NOTICE OF DECISION

DECISION OF THE PLANNING ADMINISTRATOR

SUBDIVISION TENTATIVE PLAN CASE NO.: SUB22-10

LOCATION: 1440 Boone Rd SE, Salem OR 97306

TENTATIVE
SITE PLAN

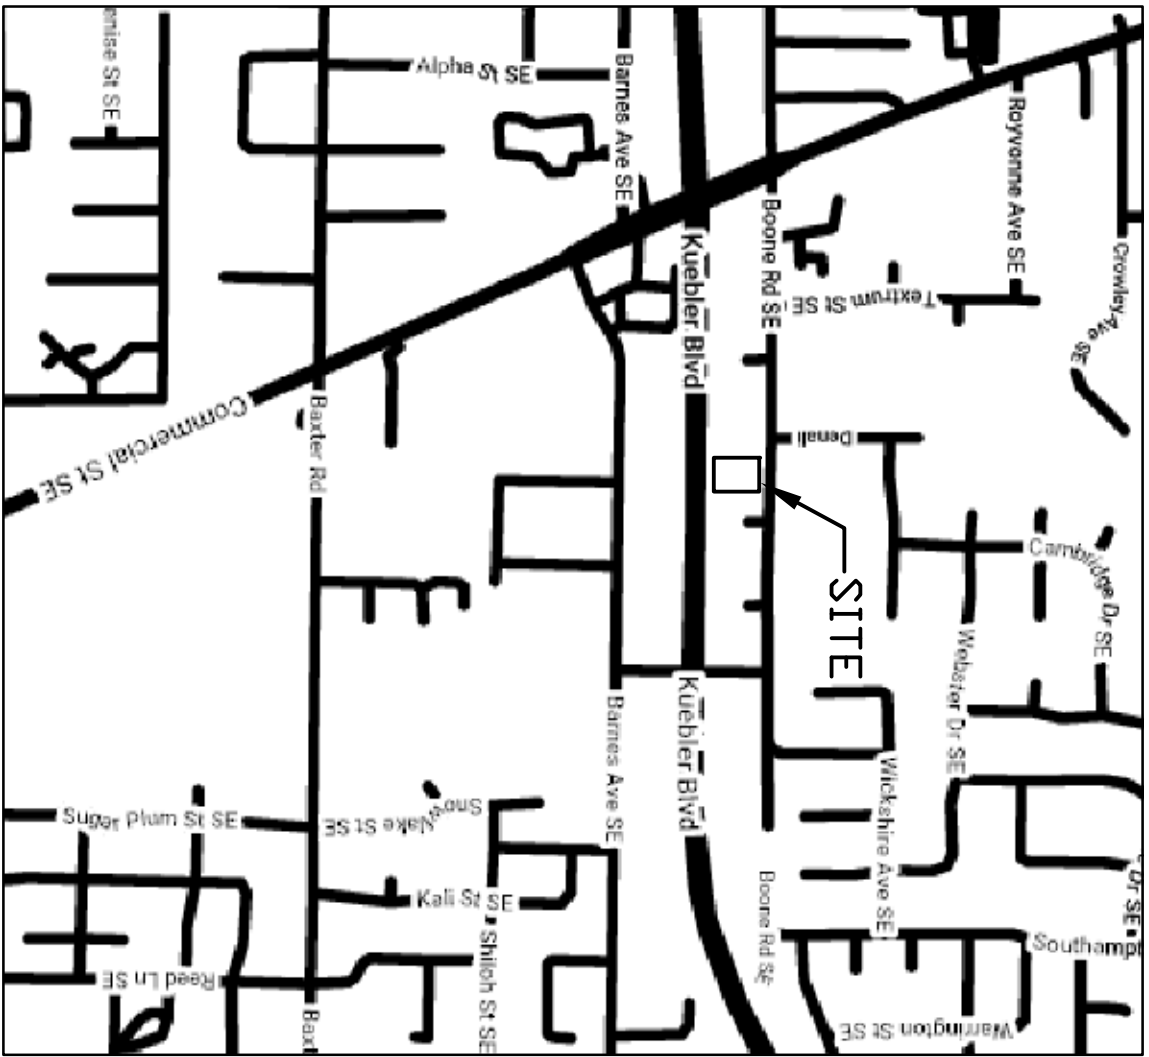
Proposed lots 5-9 are flag lots. As shown on the applicant's tentative subdivision plan, the flag lot accessway serving lots 5-9 is approximately 25 feet in width and 140 feet in length, in conformance with the standards for flag lot accessways serving 1-2 lots.

SRC 800.025(e) provides that within a subdivision, up to 15 percent of the lots may be flag lots. The proposed phased subdivision tentative plan includes four-lots with eight lots proposed to be a flag lot, exceeding the 15 percent maximum. The intent of this restriction on the number of flag lots is to provide a street to serve lots. To ensure this is met, the accessway shall be a private street. The property cannot provide a standard street section and an alternative street standard is addressed below analyzing the minimum necessary to provide adequate access.

SRC Chapter 71 (Stormwater): The proposed partition is subject to the stormwater requirements of SRC Chapter 71 and the revised Public Works Design Standards (PWDS) as adopted in Administrative Rule 109, Division 004. To demonstrate that the proposed parcels can meet the PWDS, the applicant shall provide an engineered tentative stormwater design to accommodate future impervious surface on all lots.

The applicant's proposal is to serve Lots 5 -8 with a flag-lot accessway. The proposal will not meet SRC 800.025 and therefore a condition of approval requires a private street. The private street will require an Alternative Street Standard. Pursuant to SRC 803.020(b)(2), private streets shall be constructed to a public street standard. Staff recommends a minimum 22-foot improvement width, to accommodate two 11-foot travel lanes, and a five-foot sidewalk to provide safe pedestrian access to the residential development. The infill subdivision contains physical constraints, minimal width, that prevents the applicant from meeting SRC 803.020(b)(2). Pursuant to SRC 803.065(a)(1), the Director authorizes use of an alternative street standard for the new internal private street to allow for more efficient and denser in-fill development where the physical constraints do not allow for a public street to be constructed to local street standards through the site.

SRC 803.040 (Boundary Streets): Boone Road SE abuts the subject property and does not meet the current right-of-way or improvement width standards for a Local street. In order to ensure that boundary street improvements are implemented consistent with the Transportation System Plan and Public Works Design Standards, the following condition applies;

Condition 1: All lots within the subdivision shall be developed with townhouse development.

Condition 2: Lot 1-4 shall provide access to Boone Road SE.

Condition 11: Provide an engineered stormwater design pursuant to SRC 71 and PWDS to accommodate new impervious surfaces in rights-of-way and future impervious surfaces on all proposed lots.
